REVISED STAFF REPORT AND RECOMMENDATION TO THE DESIGN COMMISSION

CASE FILE: LU 13-147922 DZM AD – Janey II Apartments
Pre-App.: EA 12-173395 PC
REVIEW BY: Design Commission
WHEN: Thursday August 15, 2013 @ 1:30 PM
(continued from July 18, 2013)
WHERE: 1900 SW Fourth Ave., Room 2500A
Portland, OR 97201

ELEVATION - EAST - B&W

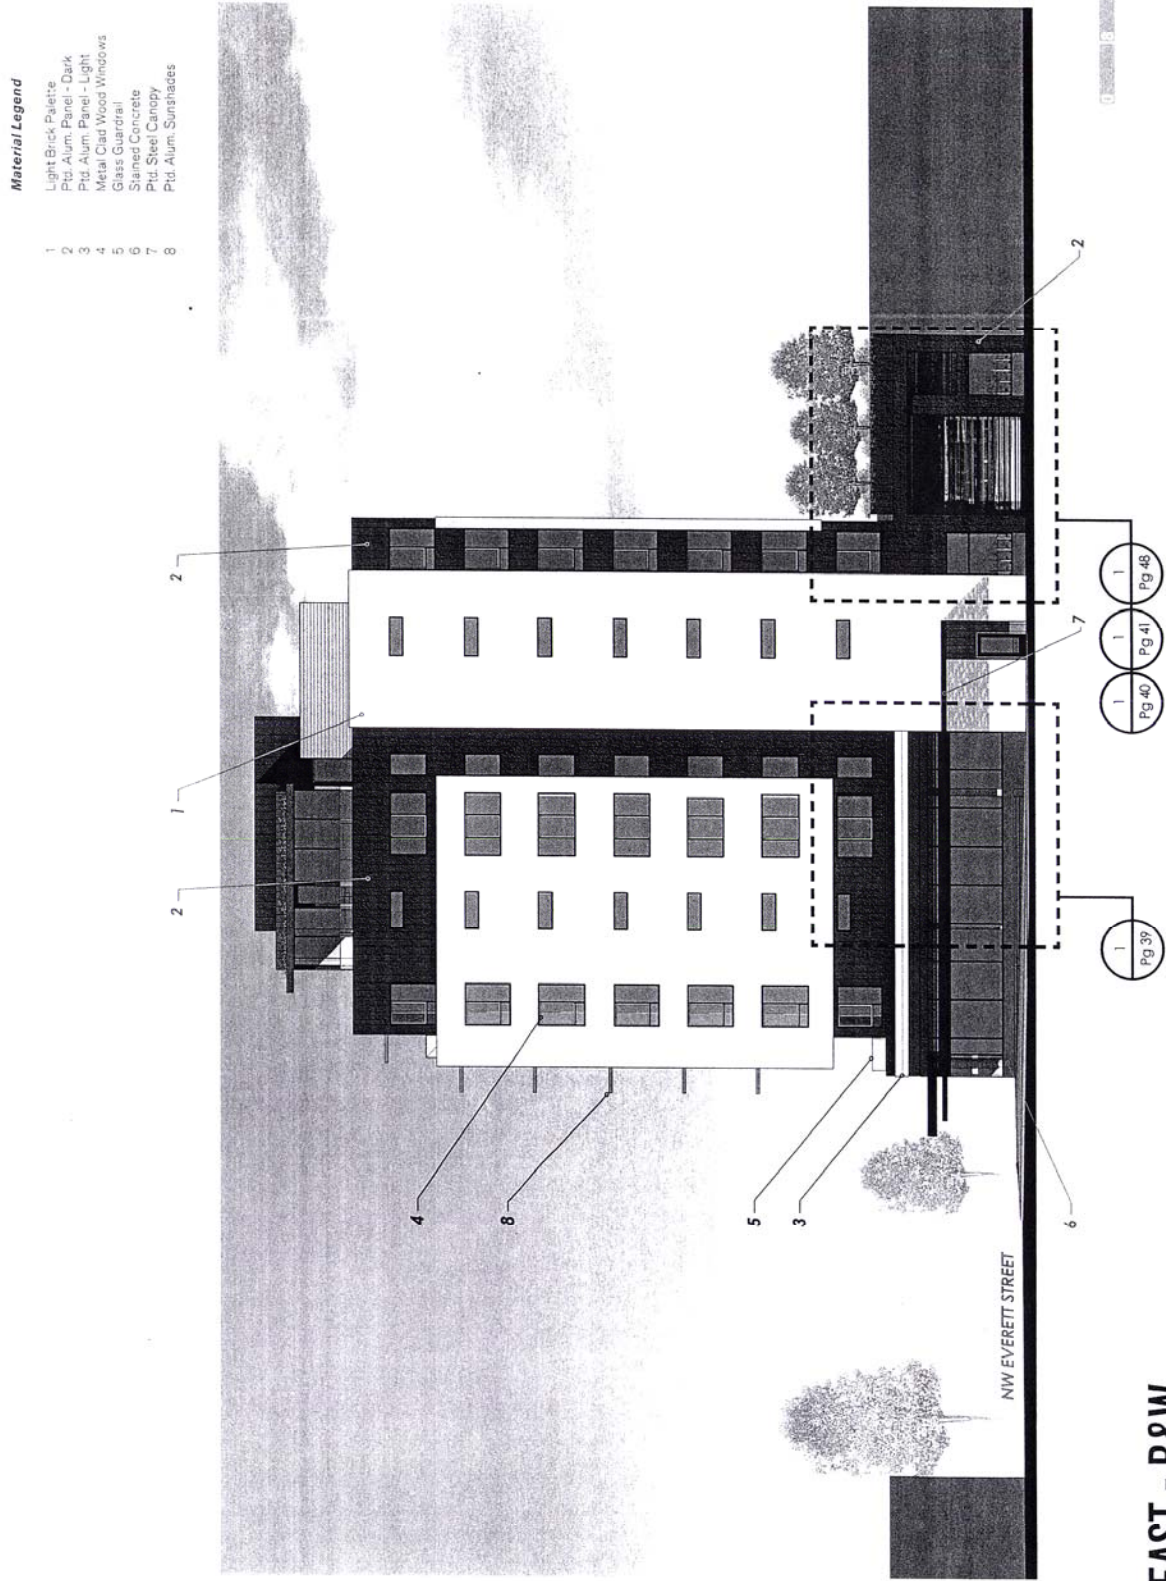
- **Metal panel at the ground floor along NW 11th.** The applicant has substituted dark metal panel skin for the previous brick surrounding the loading bay on NW 11th. While generally viewed as a quality material, extensive use of metal panel at the ground floor may result in damaged material through vandalism or other pedestrian actions over time. The Janey I building uses a dark brick at the ‘sidecar’ for the garage entry. Design Commission may wish to discuss the durability and longevity of the revised street-level materials at the continued hearing; and

- **Soffit lighting at garage windows.** The applicant has revised the proposal to add a new window just north of the garage door, and provide a 1'-0" inset from the outside building edge/lot line in NW 11th for the coiling garage door and adjacent window and louver to the north. In their cover memo with the revised drawings, the applicant indicated that the resulting new soffit would include downlights, but specific details or lighting were not been included in the drawings (and therefore are not approved). If it is the applicant’s intention to add lighting to these areas, additional information on the fixture type and location should be provided and reviewed. With downlighting only sparingly used at the pedestrian entries on the project, and with the idea being to create indoor-outdoor visual connections at the garage, downlighting might create glare for pedestrians or be unnecessary due to the garage windows. Design Commission may wish to discuss this aspect of the revised proposal at the continued hearing; and
